Subject:

Re: Planning Commission Agenda Item #20-093PL
Proposed mixed-use project at 201 West Pacific Coast Highway

Re: Comment on 201 PCH Project, Addendum No. 10 to the Midtown Specific Plan; Nov. 5, 2020 Planning Commission Agenda Item 3, 20-093PL.

We have reviewed the September 2020 Addendum No. 1 to the Midtown Specific Plan ("Addendum") for the 201 West PCH Project ("Project") in the City of Long Beach ("City"). The Project proposes to demolish the existing 9,100-SF of supermarket and surface parking and construct two five-story buildings, including 138 residential units and 25,000-SF of commercial space, as well as 238 parking spaces, on the 1.59-acre site.

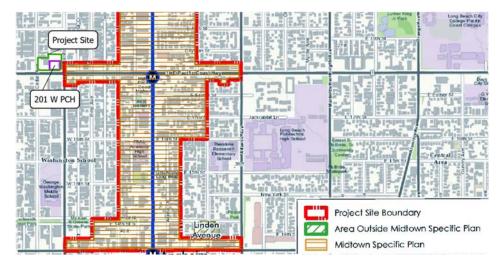
The Project site includes a hazardous waste site listed on the California State Water Resources Control Board Geotracker website.<sup>1</sup> The site, Truck and Brake Specialties, located at 231 W. Pacific Coast Highway, is listed as open and has not been remediated. This is new information that constitutes a significant impact not analyzed or mitigated in the 2016 EIR. As previously described, the 2016 EIR did not cover the area of the Project, including the 231 W. Pacific Coast Highway hazardous waste site as shown below in the map we prepared for this review.

The 231 W. Pacific Coast Highway hazardous waste site was the subject of an order<sup>2</sup> issued by the Los Angeles Regional Water Quality Control Board a week-and-a-half prior to the preparation of this letter (and subsequent to the preparation of the Addendum). The Order states, in part, that the owner of the parcel is required to take corrective action (i.e., preliminary site assessment, soil and water investigation, corrective action plan implementation, and verification monitoring) "to ensure protection of human health, safety, and the environment." This order and a June 23, 2020 Regional Board directive requiring a report to provide details regarding installation of six groundwater monitoring wells at the Site, was not disclosed in the Addendum
